Subject: McGuire Nuclear Station
Docket Numbers 50-369 and -370
Catawba Nuclear Station
Docket Numbers 50-413 and -414
Technical Specification Revision to Change Method of
Measuring Reactor Coolant System Flow Rate; Supplemental
Information

REQUEST FOR ADDITIONAL INFORMATION
REACTOR COOLANT SYSTEM (RCS) FLOW MEASUREMENT METHODOLOGY

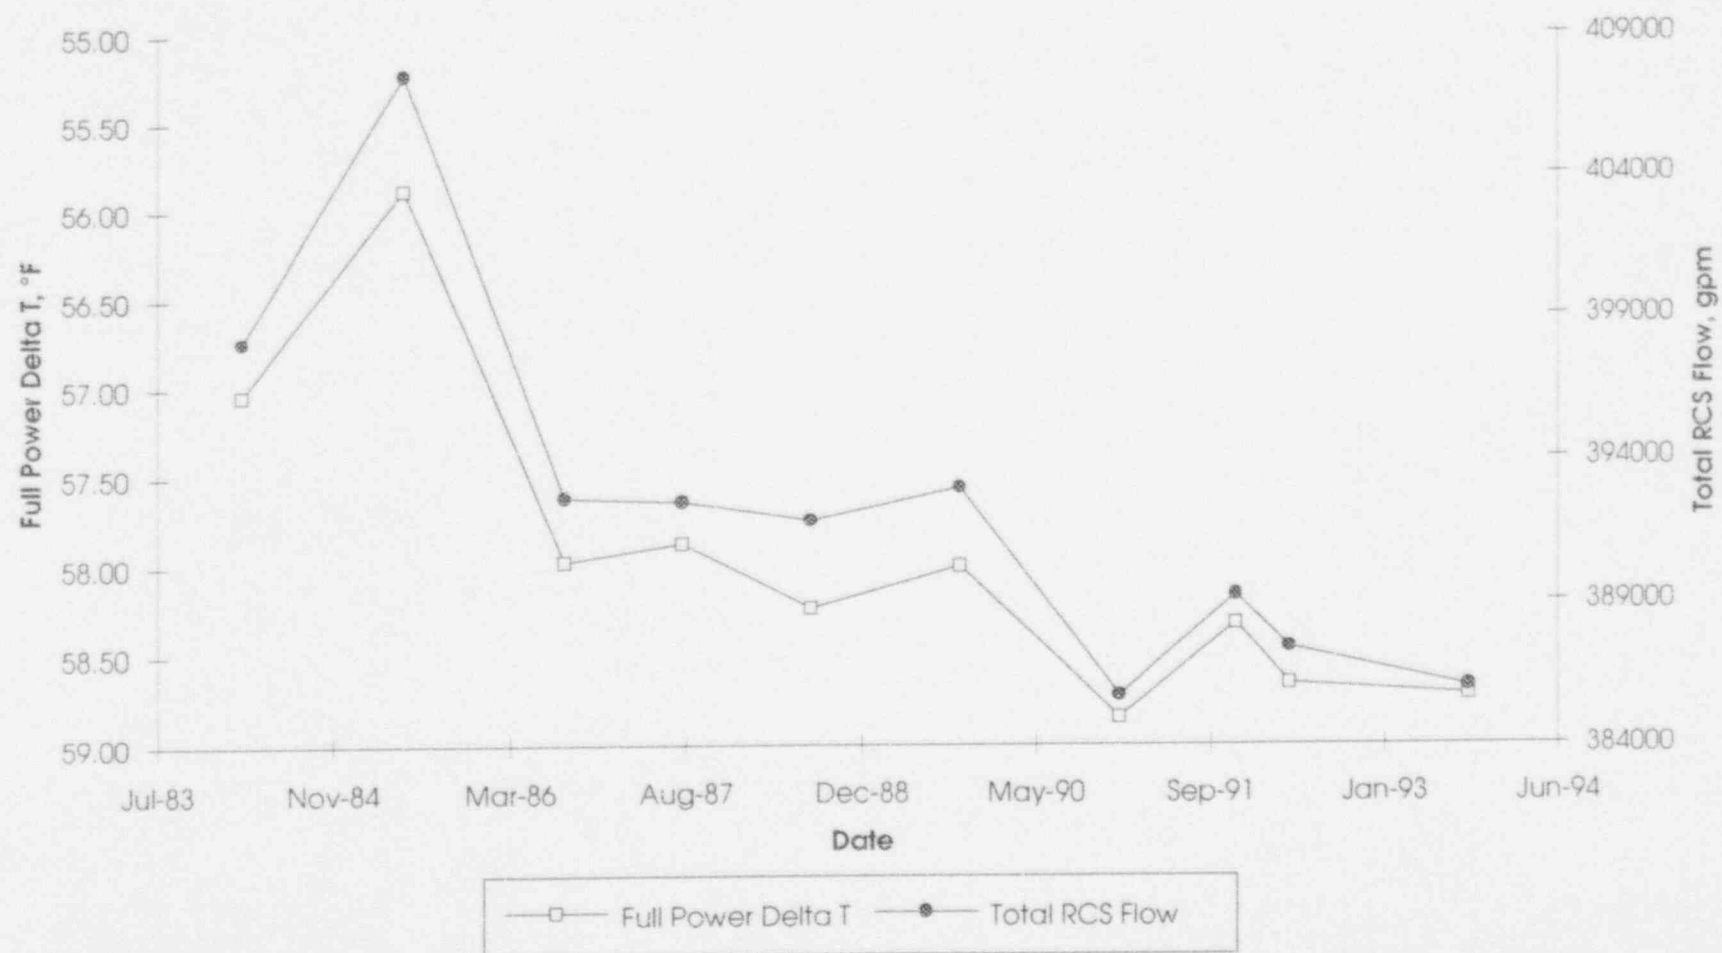
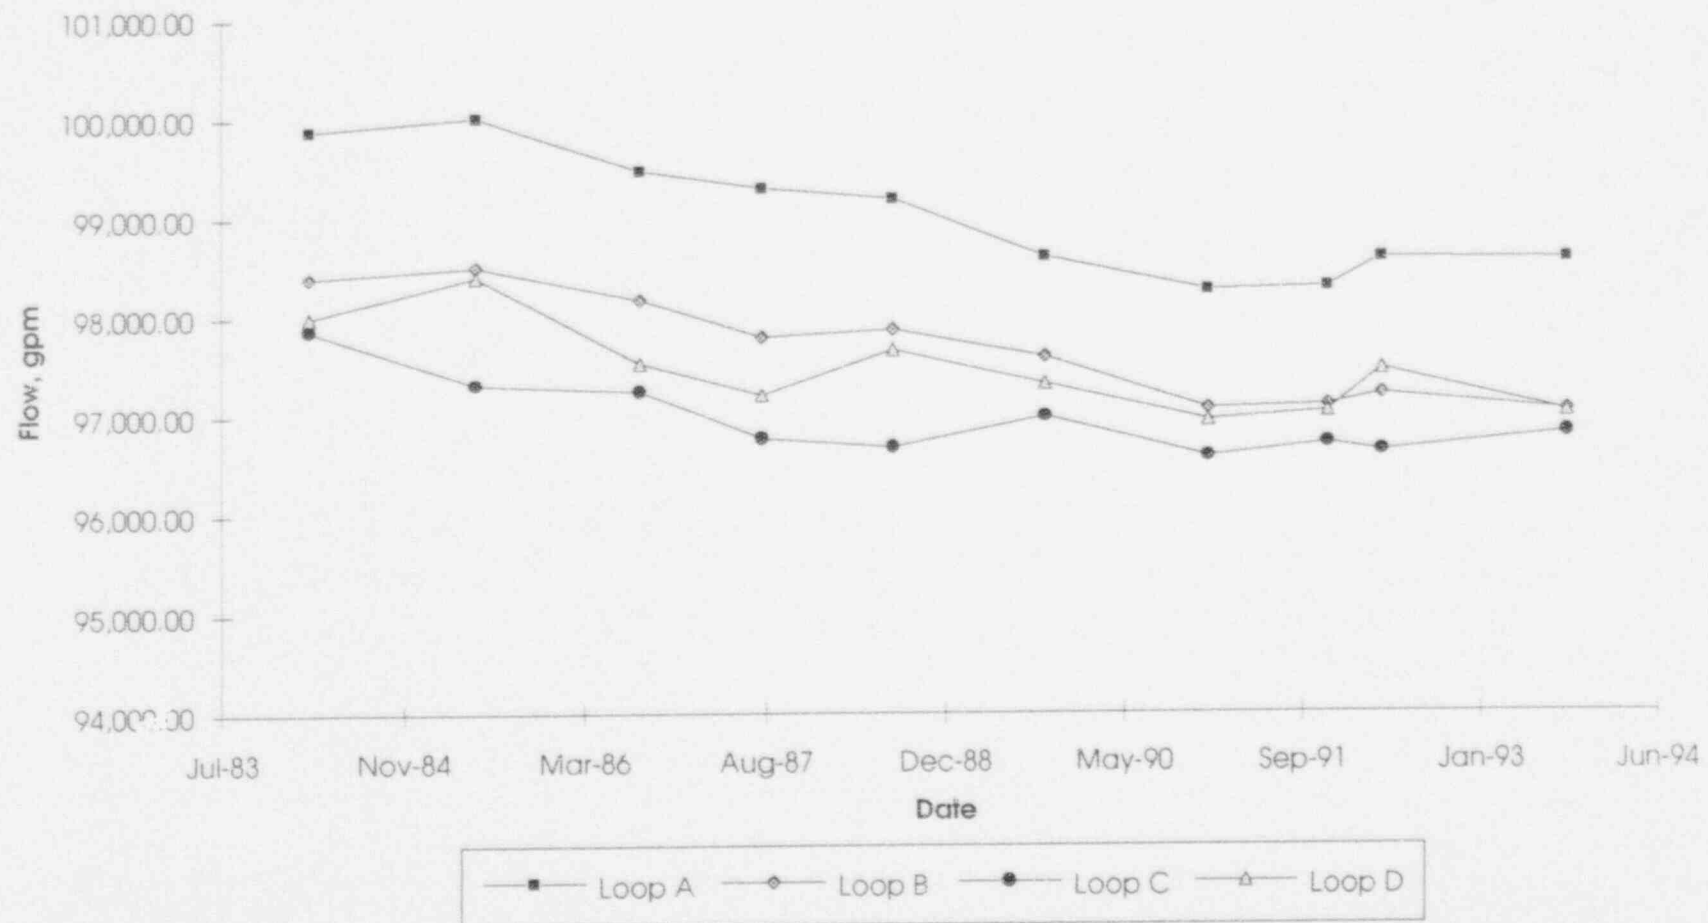
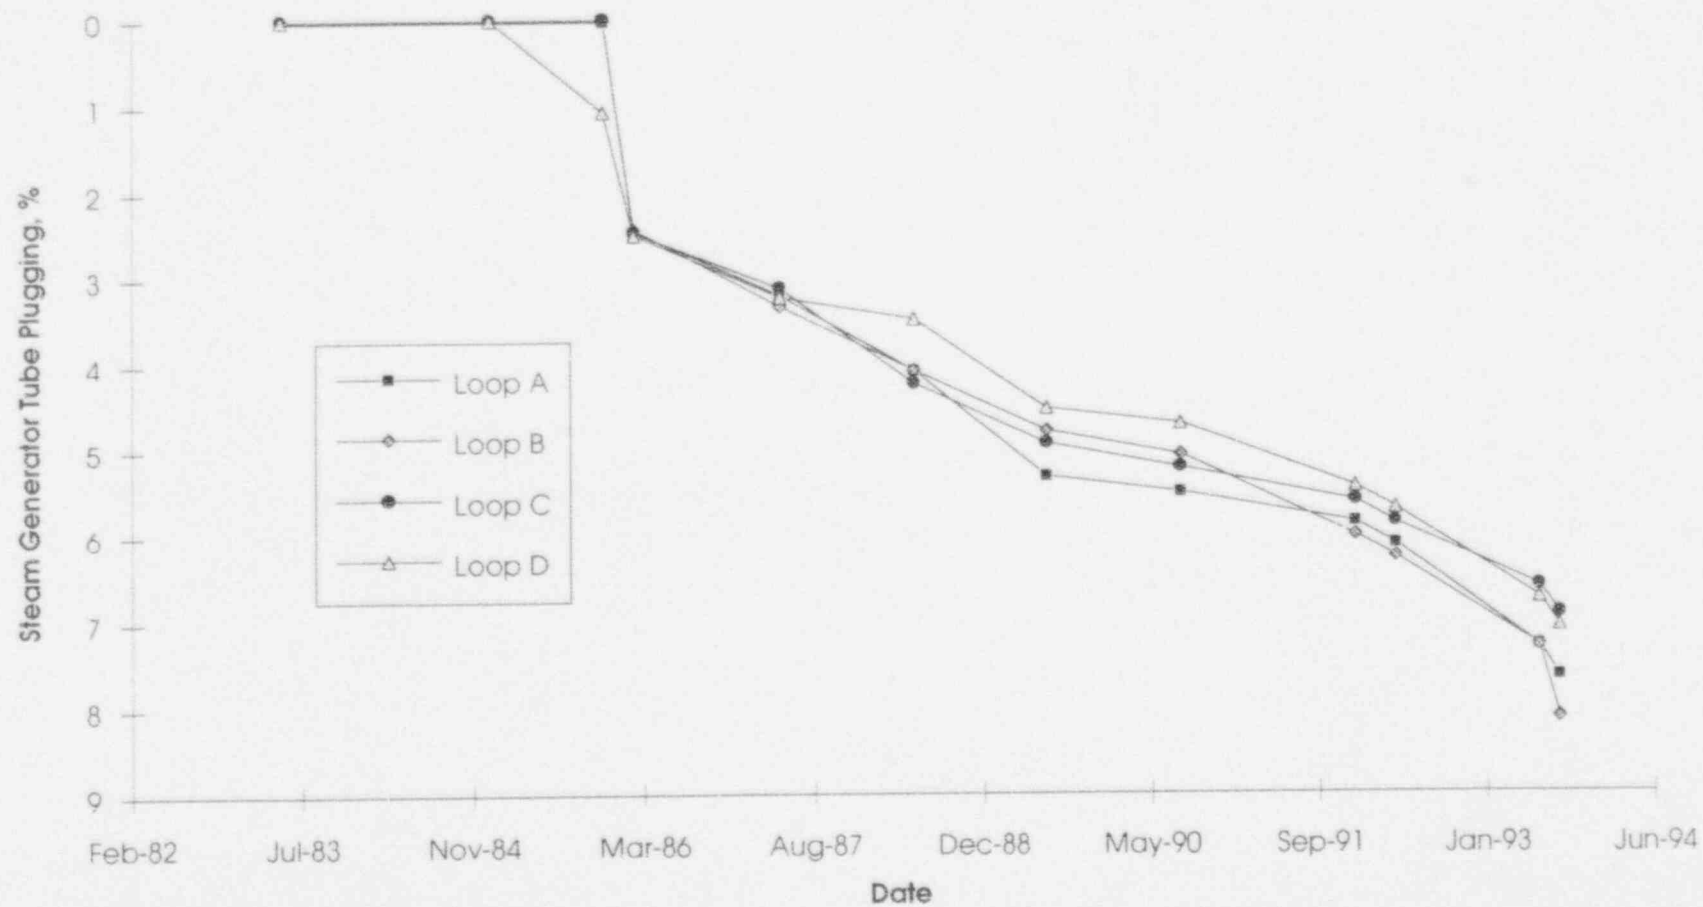
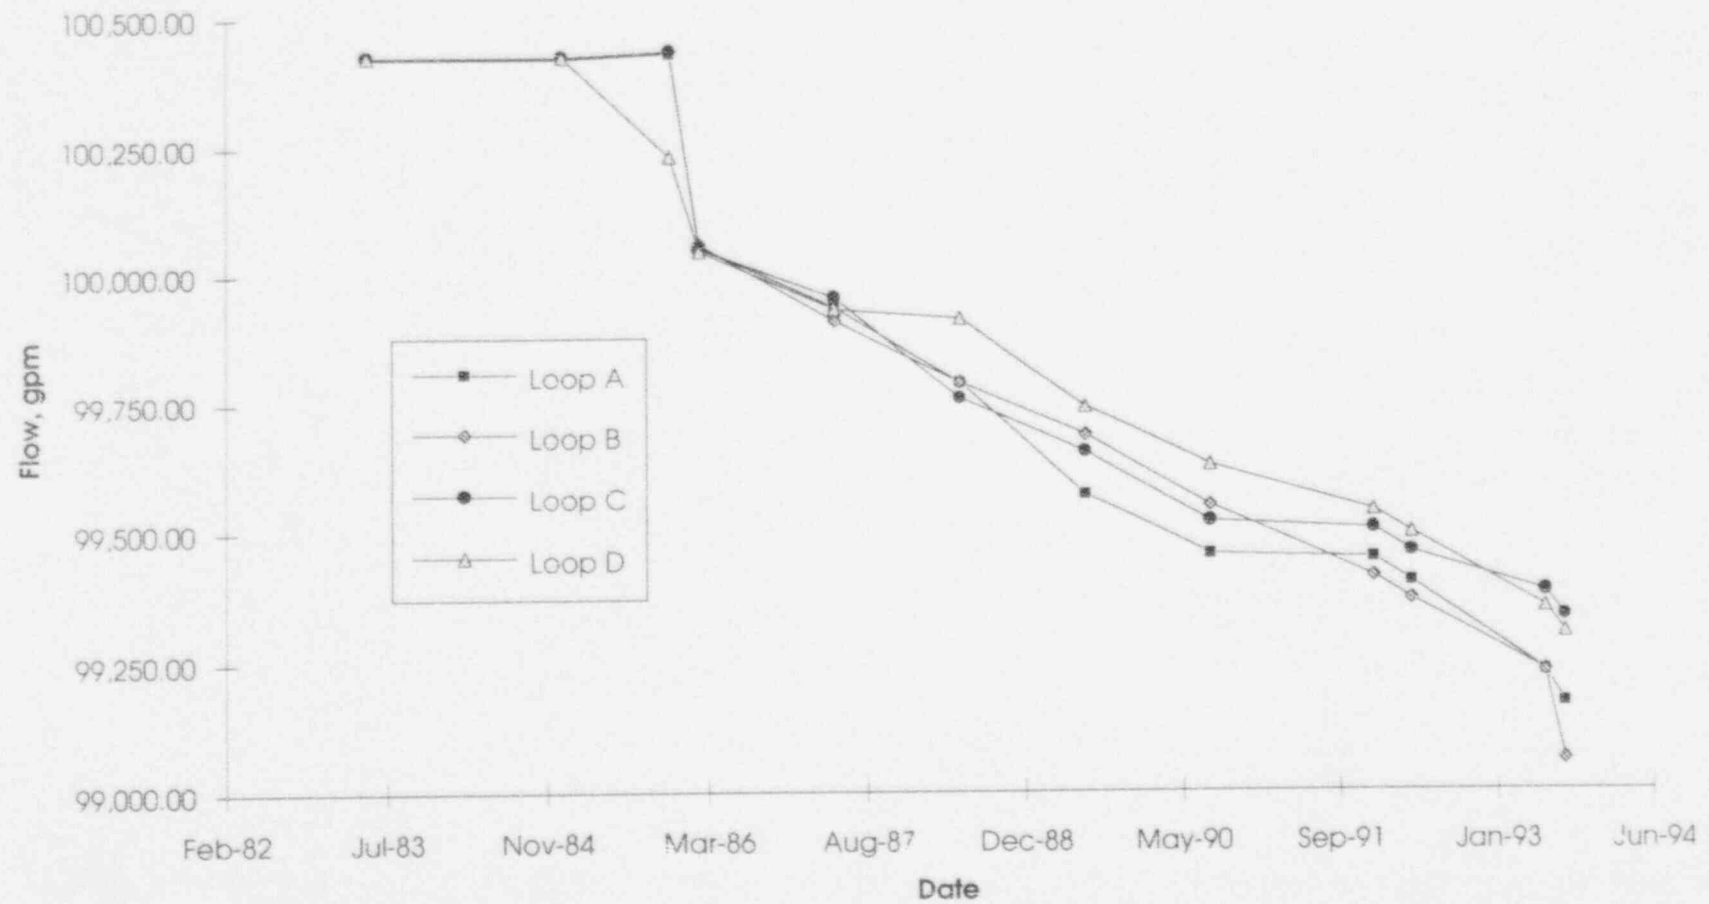
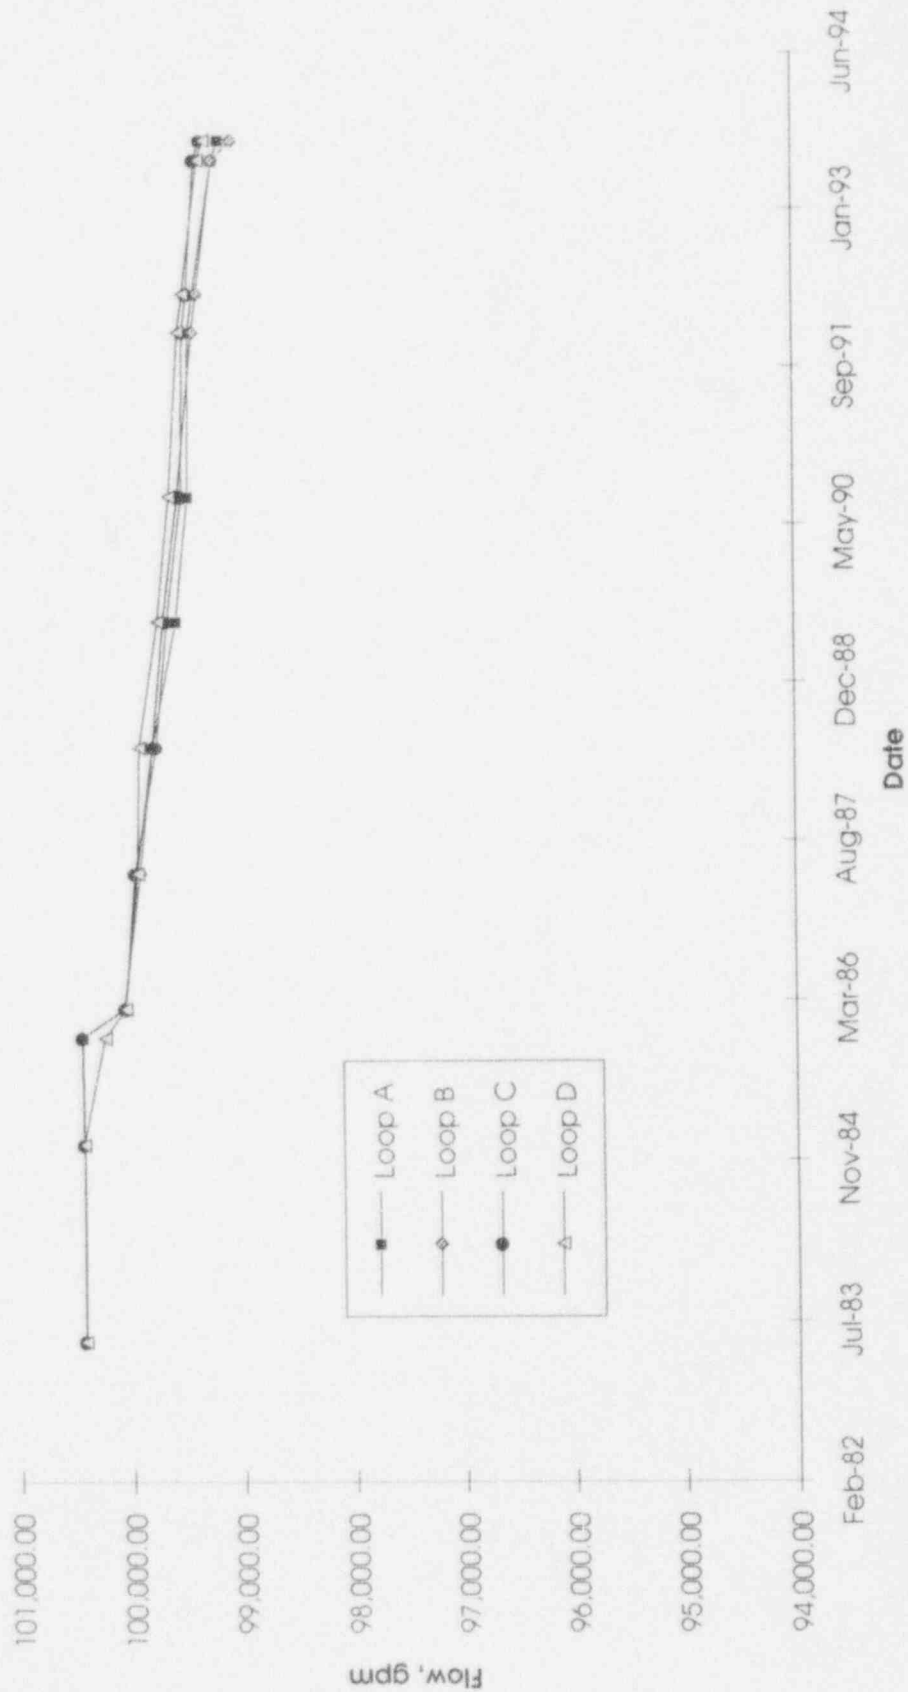
- (13) The data presented on the handouts in the February 10, 1994, meeting shows that the flow rate indicated by the calorimetric heat balance method approximates that indicated by the elbow taps except for the McGuire Unit 2 in 1985, Catawba Unit 2 up until 1990 and Catawba Unit 1 in October 1992 and January 1994. Provide an assessment for each of these divergencies.

McGuire Unit 2 has experienced a significant flow impact as a result of hot leg streaming. The RCS flow as measured by the calorimetric has trended very closely to the changes in full power ΔT as can be seen in Figure 7. The calorimetric performed February 1985, just after the EOC 1 refueling outage, indicated a large increase in RCS flow which was not accompanied by significant plant changes. The large increase in flow was the result of a decrease in indicated ΔT of approximately 1 °F as can be seen on Figure 7. This decrease in ΔT was investigated by Duke and Westinghouse and found to be caused primarily by hot leg streaming changes and a reduction in thermal power caused by feedwater venturi fouling. For the same calorimetric the individual loop flows as determined by the elbow tap ΔP s (Figure 8) and the analytical flow model (Figures 10 & 11) do not show a corresponding increase in flow. Note, Figures 10 & 11 differ only in the Y-axis scale with the scale on Figure 11 matching the scale of Figure 8 for easy comparison. In addition, no changes in plant geometry (SG tube plugging, etc.) were made prior to this calorimetric which would indicate a significant flow increase or decrease (Figures 9 & 10).

The calorimetric flows following the February 1985 calorimetric have basically trended downward consistent with the increasing trend in ΔT , but in excess of that expected by plant geometry changes. Since plant startup the calorimetrics have indicated that the total RCS flow has dropped approximately 11,000 gpm (Figure 7) whereas the elbow tap and analytical model flow has indicated a drop in total flow of approximately 4,500 gpm (Figures 8 & 10). This indicates a significant impact from hot leg streaming as it shows that 6,500 gpm of the calorimetric flow decrease can be attributed to this phenomenon.

The upflow modification was made during the August 1990 EOC 6 refueling outage. As mentioned in the discussion of the upflow modification at McGuire Unit 1, this modification was expected to change the RCS flow distribution through the core region and not effect the total flow result significantly. However, the calorimetric flow following this outage decreased approximately 7,500 gpm to just above the then Technical Specification minimum measured flow limit of 385,000 gpm (Figure 7). Since the steam generator tube plugging percentage during the EOC 6 refueling outage was small this magnitude of flow decrease was not expected. The elbow tap and analytical flow model for the same time frame indicate a flow decrease of \approx 500 gpm which is consistent with the percentage of steam generator tube plugging which occurred during the outage.

An end of cycle calorimetric was performed just prior to the January 1992 EOC 7 refueling outage to determine if core burnup resulting in the flattening of the core exit temperature profile would increase the calorimetric measured flow. As expected the flow determined from this calorimetric did increase ($\approx 3,000$ gpm). This indicates that the unsubstantiated flow decreases measured by the calorimetrics are the result of hot leg streaming changes, as suspected.

The first batch of B&W fuel was introduced during the January 1992 EOC 7 refueling outage. The B&W fuel was expected to increase flow slightly due to the decreased flow resistance in the core. This increase in flow due to the new fuel was expected to be offset by steam generator tube plugging as shown in Figures 10 & 11. The flow in the plant as indicated by the elbow tap ΔP s actually increased slightly after this outage. This is likely due to the new fuel having a greater effect on the flow than anticipated and partially due to the analytical flow model assumption that 1/3rd of the core would be replaced when slightly more was in fact replaced ($\approx 37\%$). The July 1993 EOC 8 refueling outage, which involved a second batch of B&W fuel and additional steam generator tube plugging resulted in a flow decrease as measured by the calorimetric. The elbow tap ΔP s and analytic model flows indicate no decrease and a slight decrease respectively.

The large increase in flow for McGuire Unit 2 in 1985 is the result of a decrease in indicated ΔT of approximately 1 °F. This decrease in ΔT was investigated by Duke and Westinghouse and found to be caused primarily by hot leg streaming changes and a reduction in thermal power caused by feedwater venturi fouling. As can be seen in Figure 5 the RCS total flow was largely the result of this change in ΔT . For the same calorimetric the individual loop flows as determined by the elbow tap ΔP s (Figure 6) do not show a corresponding increase in flow. In addition, no changes in plant geometry (SG tube plugging, etc.) were made prior to this calorimetric which would indicate a flow increase or decrease (Figures 7 & 8).

Figure 12

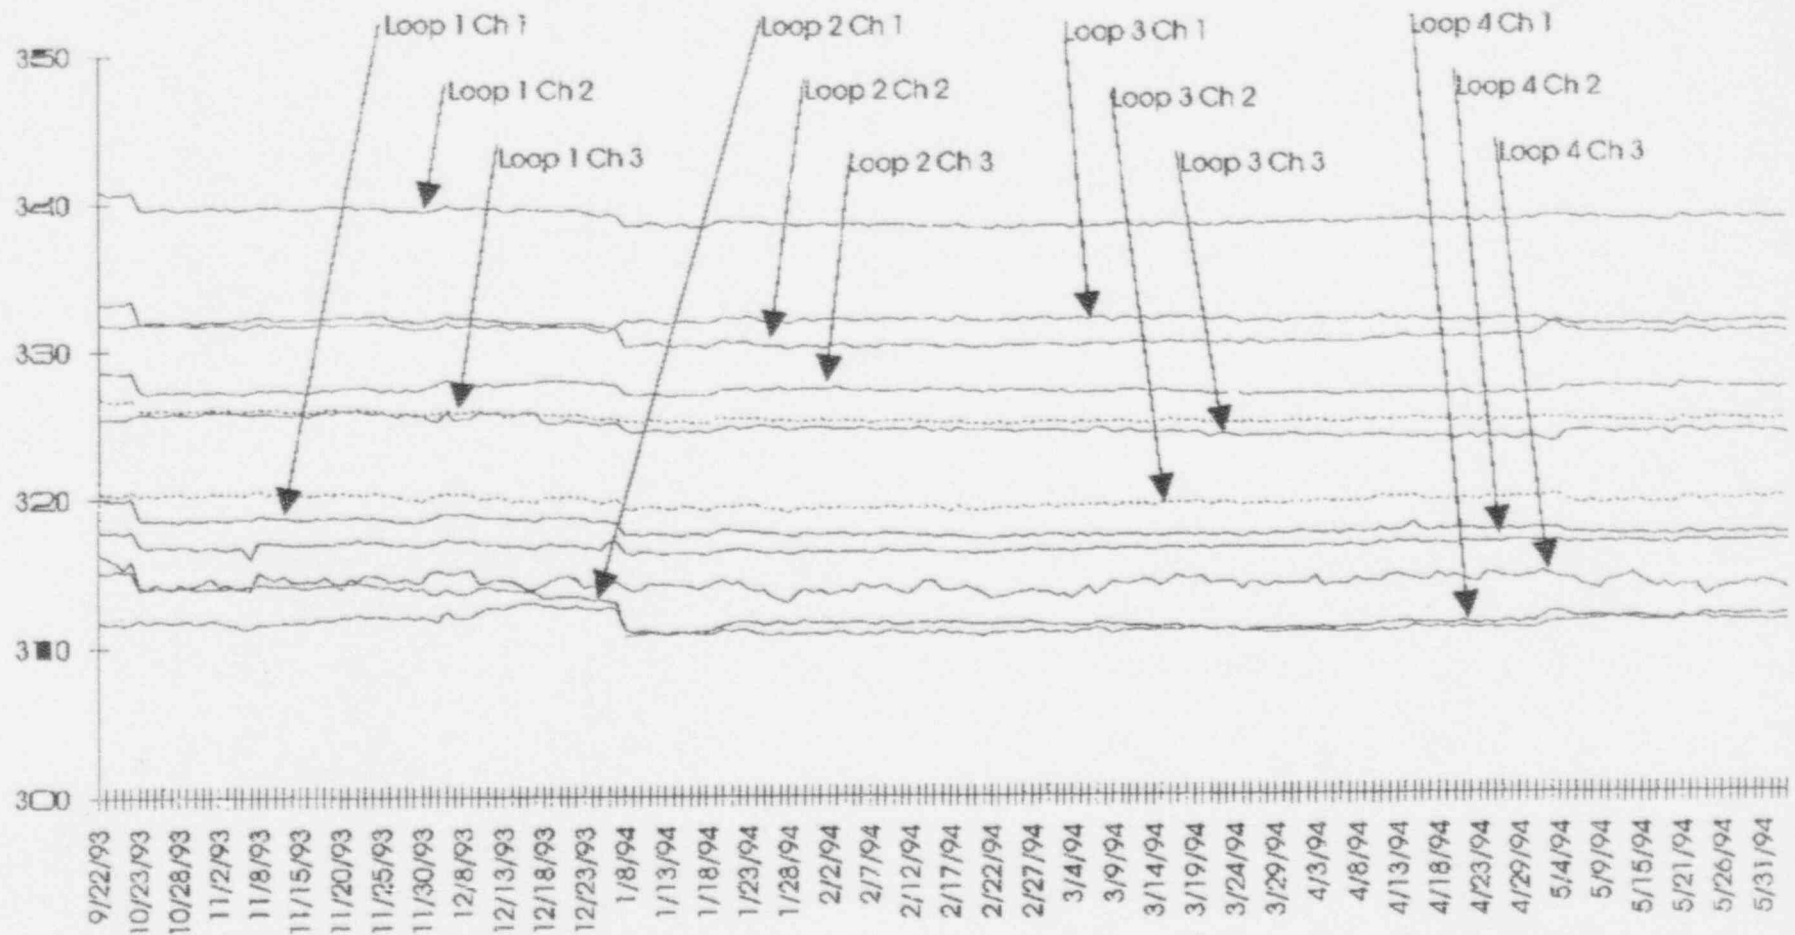
- (8) Please provide a comparison of analyses and observed RCS loop/total flow rate behavior as determined from elbow tap differential pressure indications and from calorimetric testing for both Catawba and both McGuire units. Sufficient data should be used to establish that:

Figure 12 shows the daily average elbow tap ΔP data for McGuire Unit 2 back to September 22, 1993. This data covers cycle 8 and has been modified to eliminate bad data and data at off power days ($<99\%$ power). The data shows that the elbow tap ΔP s are very steady with no major drifting trends when the transmitters are operating properly. The elbow tap data in Figure 12 shows changes in loop flow resistances due to SG tube plugging performed during the SG tube leak outage which ended in October 1993.
